EXHIBIT A: 2018 ICC and 2017 NEC Code Amendments

Chapter 4 – BUILDINGS BUILDINGS AND BUILDING REGULATIONS

ARTICLE I. – BUILDING CODE TECHNICAL CODES

Figure R602.6.1; delete the figure and insert the following figure:

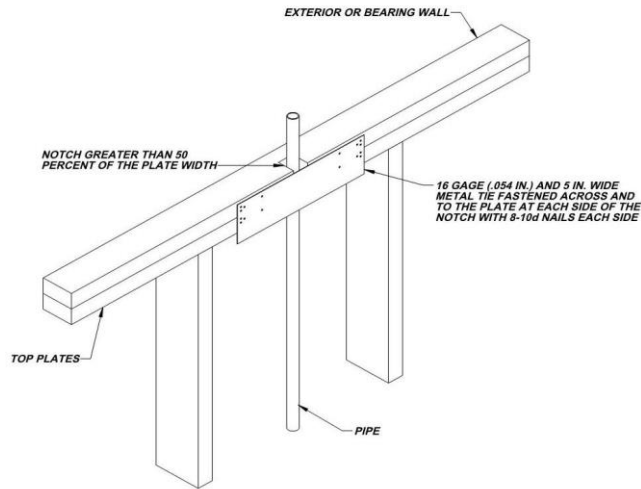
Section R602.6.1; amend the following:

R602.6.1 Drilling and notching of top plate. When piping or ductwork is placed in or partly in an exterior wall or interior load-bearing wall, necessitating cutting, drilling or notching of the top plate by more than 50 percent of its width, a galvanized metal tie not less than 0.054 inch thick (1.37 mm) (16 Ga) and ~~1 ½ inches (38 mm)~~ 5 inches (127 mm) wide shall be fastened across and to the plate at each side of the opening with not less than eight 10d (0.148 inch diameter) having a minimum length of 1 ½ inches (38 mm) at each side or equivalent. Fasteners will be offset to prevent splitting of the top plate material. The metal tie must extend a minimum of 6 inches past the opening. See figure R602.6.1. {remainder unchanged}

ADD: Figure: 25 TAC §265.186 (e) (6)

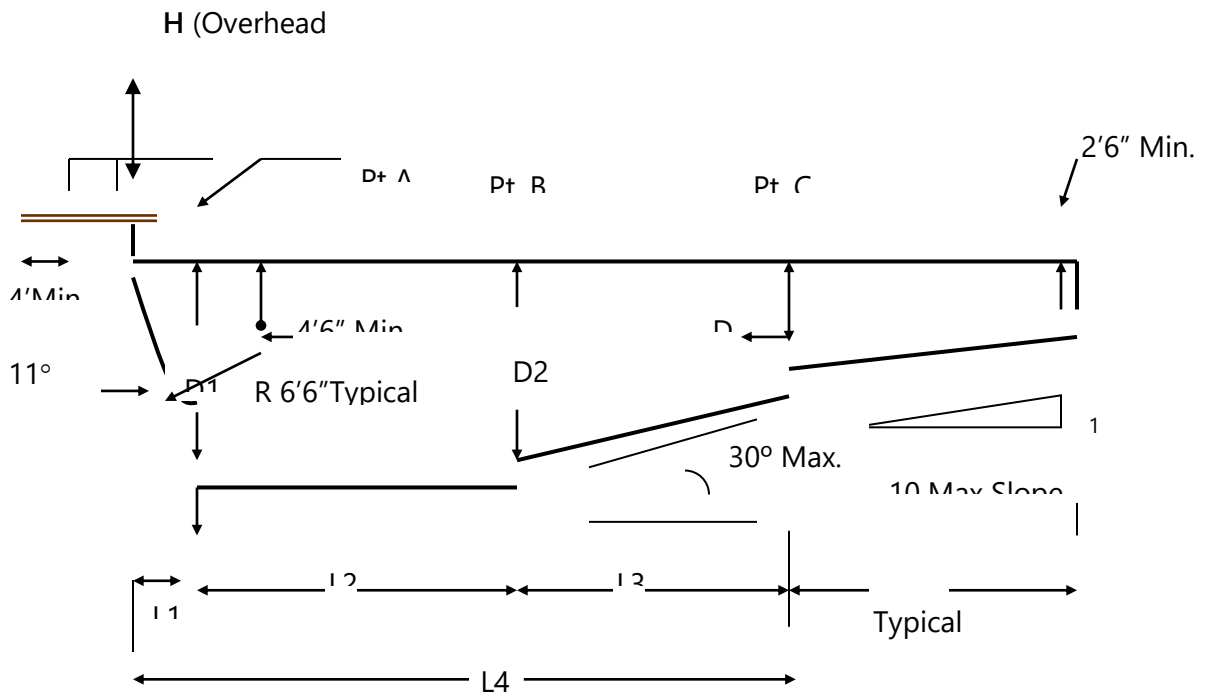
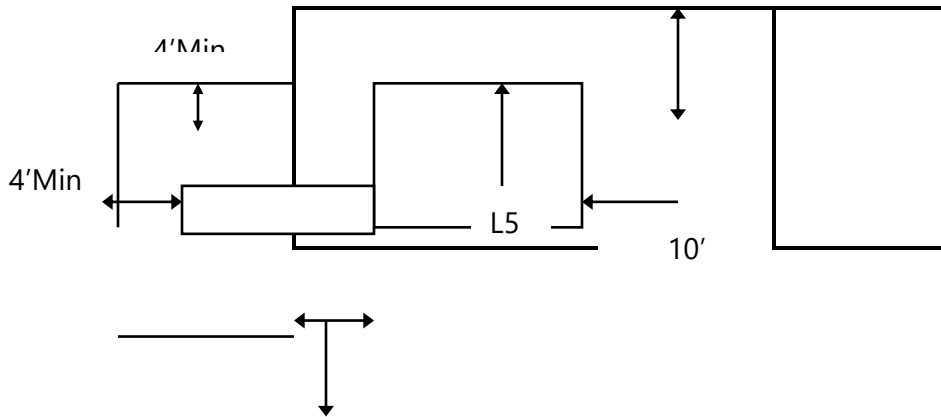
402.12 Water envelopes. The minimum diving water envelopes shall be in accordance with ~~Table 402.12~~ **Texas department of State Health services, Administrative Code Title 25, Chapter 265, Section 186 (e) and Figure: 25 TAC 256.186 (e) (6).** (Delete Table 402.12 and Figure 402.12)

Maximum Diving Board Height Over Water	¾ Meter	1 Meter	3 Meters
Max. Diving Board Length	12 ft.	16 ft.	16 ft.

Minimum Diving Board Overhang	2 ft. 6 in.	5 ft.	5 ft.
D1 Minimum	8 ft. 6 in.	11 ft. 2 in.	12 ft. 2 in.
D2 Minimum	9 ft.	10 ft. 10 in.	11 ft. 10 in.
D3 Minimum	4 ft.	6 ft.	6 ft.
L1 Minimum	4 ft.	5 ft.	5 ft.
L2 Minimum	12 ft.	16 ft. 5 in.	19 ft. 9 in.
L3 Minimum	14 ft. 10 in.	13 ft. 2 in.	13 ft. 11 in.
L4 Minimum	30 ft. 10 in.	34 ft. 7 in.	38 ft. 8 in.
L5 Minimum	8 ft.	10 ft.	13 ft.
H Minimum	16 ft.	16 ft.	16 ft.
From Plumbet to Pool Wall at Side	9 ft.	10 ft.	11 ft. 6 in.
From Plumbet to Adjacent Plumbet	10 ft.	10 ft.	10 ft.
